Informal document No. **GRSG-96-10**
(96th GRSG, 4-8 May 2009)
agenda item 2

FURTHER PROPOSALS TO REGULATION No.66.

The proposals below are additional proposals to the document
ECE/TRANS/WP.29/GRSG/2009/5.

Explanation: The sketch illustrates the problem:

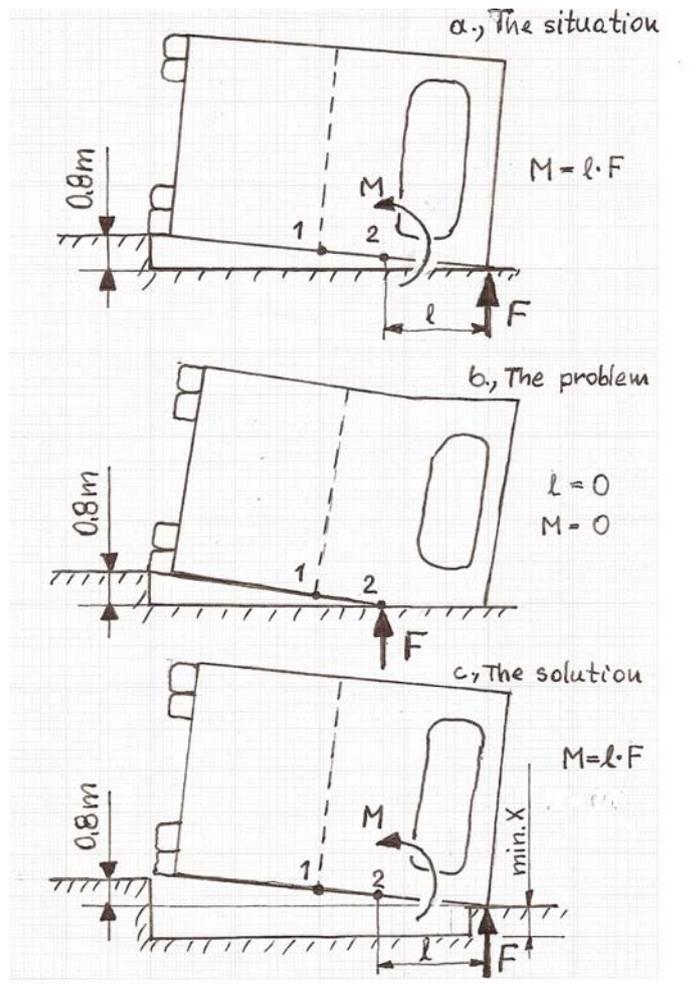
5. Double deck vehicle

This test method shall not be applied to double deck vehicles, because the geometrical configuration of this test bench limits the possible deformation of the superstructure.

- a) The basic situation in the rollover test:
- the dynamic reaction force F at the cantrail, when it hits the ground creates a bending moment M
 - the bending moment may cause large scale structural deformation, if the superstructure is not strong enough. The deformation depends on the strength of the superstructure.
- b) The problem with this geometrical configuration:
- after a slight structural deformation, before the superstructure could reach the residual space
 - the waistrail contacts the ground, the reaction force F is transferred from the cantrail to the waistrail
 - the bending moment M comes to the end (no more bending moment)

- no further deformation, even if the superstructure is not strong enough. The deformation does not depend on the strength of the superstructure.

Even it seems to be a similar test to the original one, for double deck vehicles it is a completely different test!

c) Possible solution could be:

- to use a modified, shaped ditch
- where the “mechanical depth” is the same (0,8 m), so the energy input is the same as in the original test
- the dynamic reaction force F at the conrail creates the bending moment M
- the bending moment may cause structural deformation, because there is no geometrical limitation.
